Certificate of Appropriateness

Property 2617 N. WAHL AV. North Point North
Description of work Repair brick garden wall at rear of property. Replace bricks with matching new bricks as needed. Install red-dyed stone coping along straight portion of walls with new metal drip edge. Pillars/posts must be repaired only with brick and may not using coping. Mortar is to be no harder than Type N and subject to the conditions below.
Date issued 7/19/2019 PTS ID 114812 COA: Repair rear garden wall

Current conditions.

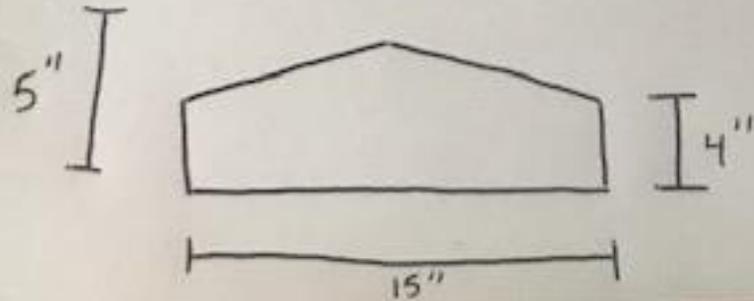
Posts must be rebuilt only with new brick. Limestone caps are not permitted.

79 Lineal Feet of coping stones

Profile of new stone coping stones, to be dyed red.

Use metal edge drip below new coping stones.
